## COVINGTON ESTATES RUD JSP21-47

### **COVINGTON ESTATES JSP21-47**

Public hearing at the request of Toll Brothers LLC for recommendation to City Council for approval of a Residential Unit Development (RUD) Plan. The subject property is located in Section 31 north of Eight Mile and west of Garfield in the RA, Residential Acreage District. The applicant is proposing a Residential Unit Development (RUD) on a 54.3 acre parcel to construct 44 single-family residential units.

## Planning Review

TOLL BROTHERS  
COVINGTON ESTATES  
RESIDENTIAL UNIT DEVELOPMENT PLAN  
UTILITY PLAN

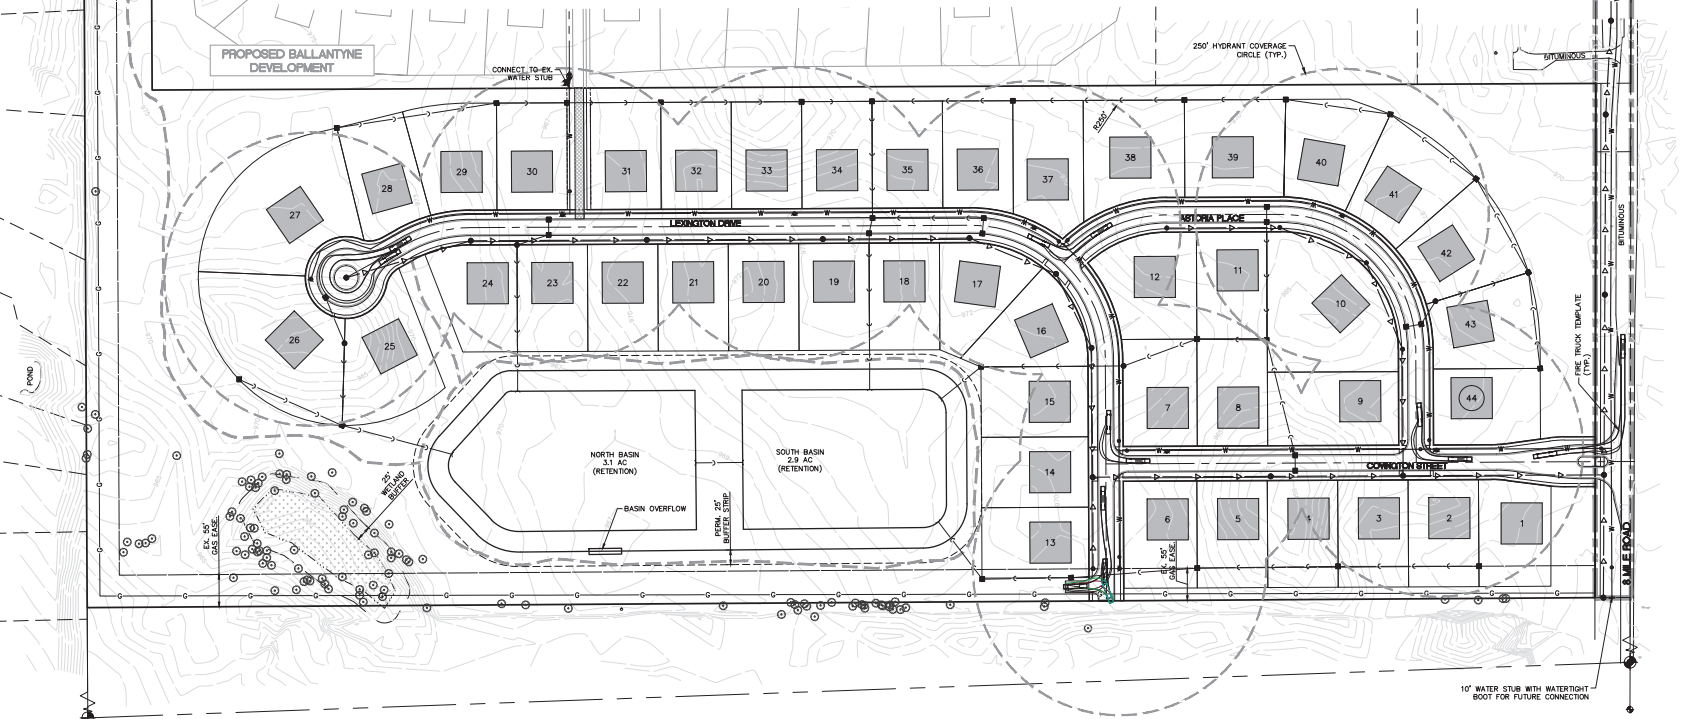
**The applicant has provided a written statement, however it is not clear how the open space to be preserved will be permanently protected. Will an Open Space Preservation Easement be granted? In addition, Sheet 6 of the plan set indicates 3.2 persons per unit for a total population of 141 persons, while the narrative indicates a total population of 176 people. Please clarify the inconsistency.**

5. RUD Intent - The applicant has provided a written statement, however it is not clear how the open space to be preserved will be permanently protected. Will an Open Space Preservation Easement be granted? In addition, Sheet 6 of the plan set indicates 3.2 persons per unit for a total population of 141 persons, while the narrative indicates a total population of 176 people. Please clarify the inconsistency.

**Response:** *Refer to the response to planning comment #1 with regard to the open space preservation. The total population of 141 persons is the correct population (as depicted in the Sanitary Basis of Design on Sheet 6).*

**PERFORATED RISER**  
NO SCALE

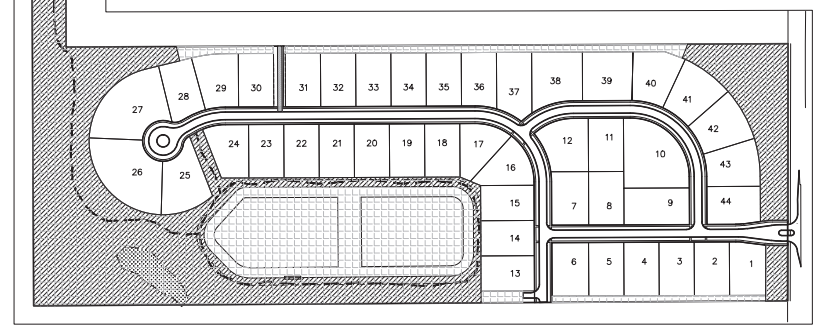
48. Remove perforated riser detail from sheet 10.  
**Response:** *This detail will be removed on subsequent plan submittals.*
49. Design construction standards state that ponds (basins) shall be designed as an integral part of the overall site plan and shall be considered a natural landscape feature having an irregular shape. It is recommended that the basin have a more natural shape.
